Project	IEEE 802.16 Broadband Wireless Access Working Group < http://ieee802.org/16 >
Title	Enhancement of Pre-authentication of PKMv2
Date Submitted	2005-01-24
Source(s)	Chulsik Yoon, Mi-young Yun, and Sungcheol Chang csyoon@etri.re.kr
	ETRI 161, Gajeong-dong, Yuseong-Gu, Daejeon, 305-350, Korea
Re:	Contribution on comments to IEEE P802.16e/D5
Abstract	In this contribution, we propose to enhance the pre-authentication concept to the various cases of authorization modes.
Purpose	Adoption
Notice	This document has been prepared to assist IEEE 802.16. It is offered as a basis for discussion and is not binding on the contributing individual(s) or organization(s). The material in this document is subject to change in form and content after further study. The contributor(s) reserve(s) the right to add, amend or withdraw material contained herein.
Release	The contributor grants a free, irrevocable license to the IEEE to incorporate text contained in this contribution, and any modifications thereof, in the creation of an IEEE Standards publication; to copyright in the IEEE's name any IEEE Standards publication even though it may include portions of this contribution; and at the IEEE's sole

Figure 1. Description of the PKMv2 Key Hierarchy

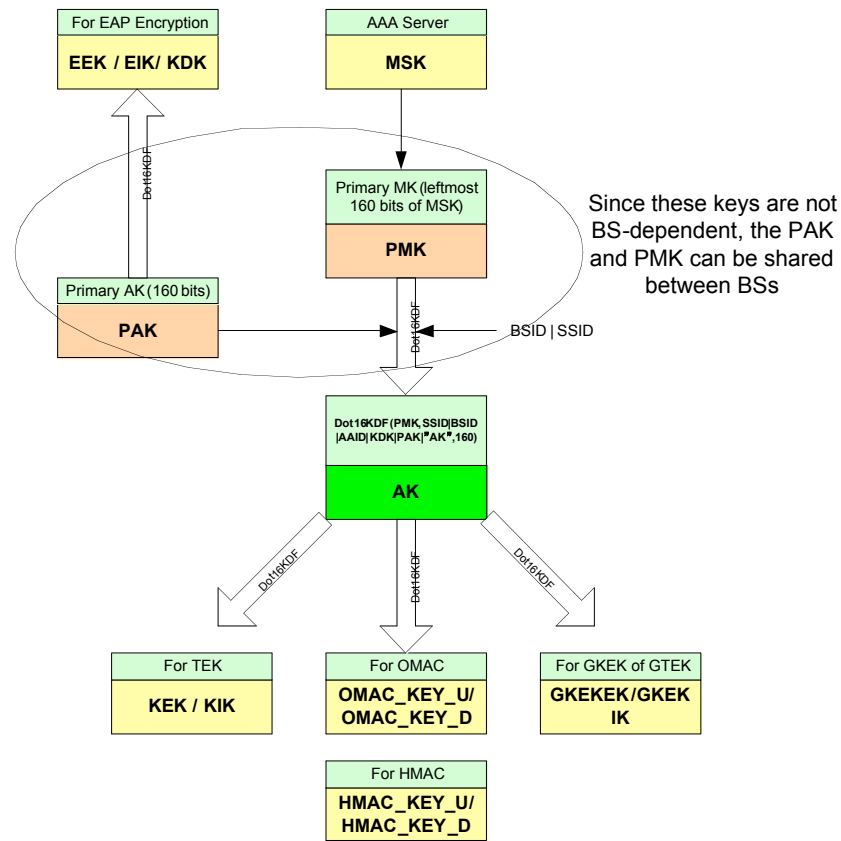
Currently, the Pre-authentication is applied to the PMK, not PAK. In Figure 1, only the right branch of the key hierarchy tree can be applied the pre-authentication for fast handover. But for most of the cases including the left branch of the key hierarchy tree (the RSA only case, RSA with EAP yielding an MK case, and the RSA with EAP not yielding an MK case), the pre-authentication cannot be applied.

[Figure 2. Description of proposed modification of key hierarchy and preauthentication concept](#)

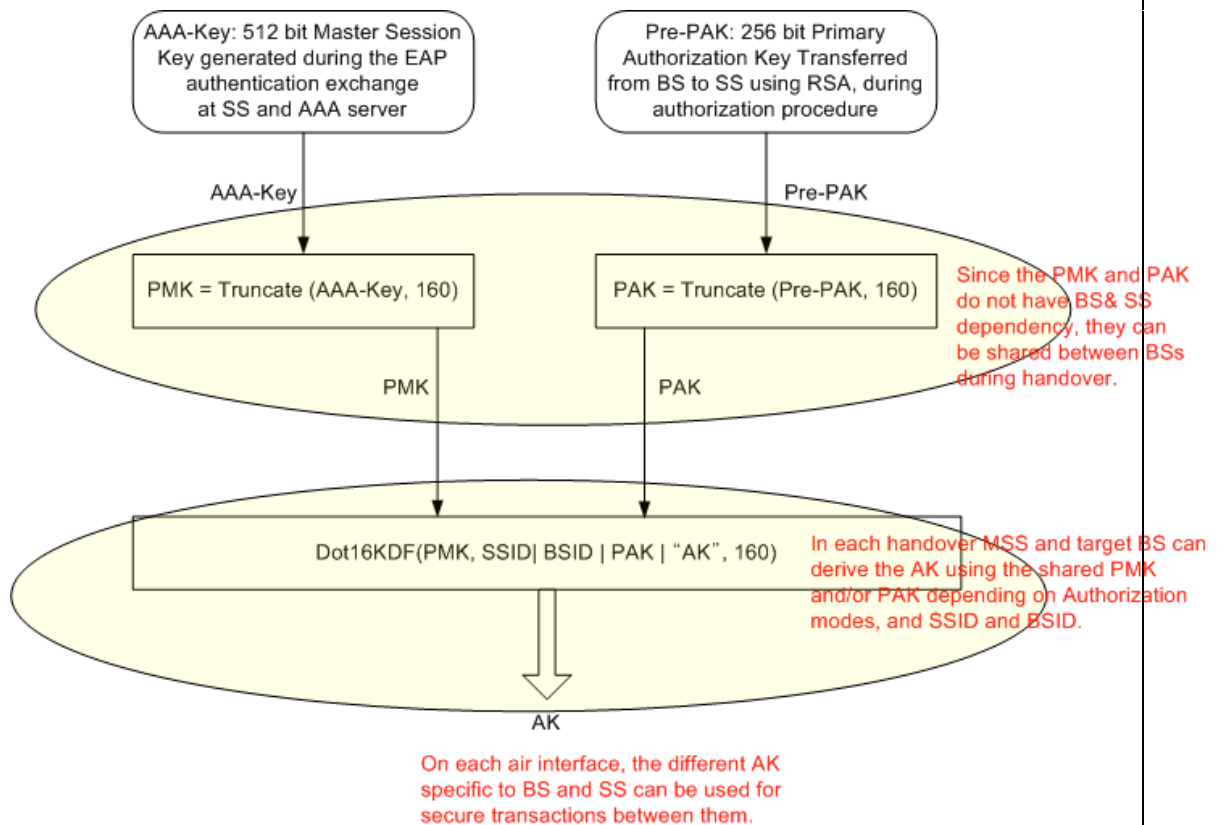
To enhance this mechanism to every case of the authentication mode, the MSS and the target BS shall share not only the PMK, but also the PAK. During the HO procedure the serving BS transfer the MSS's capability information to the target BS, and then the target BS know the authorization capability of the MSS. Therefore, the MSS and the target BS can generate the same AK using the same AK generating rule for the initial network entry procedure, without PKM message transaction between them over the air.

The PAK and the PMK sharing method between them is out-of-scope of the specification. There can be two possible methods: 1) Transfer the PMK and the PAK from the old serving BS to the target BS. 2) ASA server (including the AAA server conceptually) distribute only keeping the keys of PMK and PAK, and the BS-specific keys, i.e., the AK can be generated using the BSID and SSID as an input parameters for generating the AK and distribute to the target BS~~the same MK and PMK to the target BS.~~

Derive the AK using the AK generating rule:

AK = Dot16KDF(PMK, SSID || BSID || AAID || KDK PAK || "AK", 160);
Else If (the authorization exchange has been used yielding PAK and the EAP
authentication exchange has been used, but not yielding an MSK) then
    AK = Dot16KDF(0, SSID || BSID || AAID || KDK PAK || "AK", 160);
Else if (the EAP authentication exchange has been used, yielding an MSK) then
    AK = Dot16KDF(PMK, SSID || BSID || "AK", 160);
Else if (the authorization exchange has been used) then
    AK = Dot16KDF(0, SSID || BSID || AAID || KDK PAK || "AK", 160);
Else
    No security mode is selected
End if
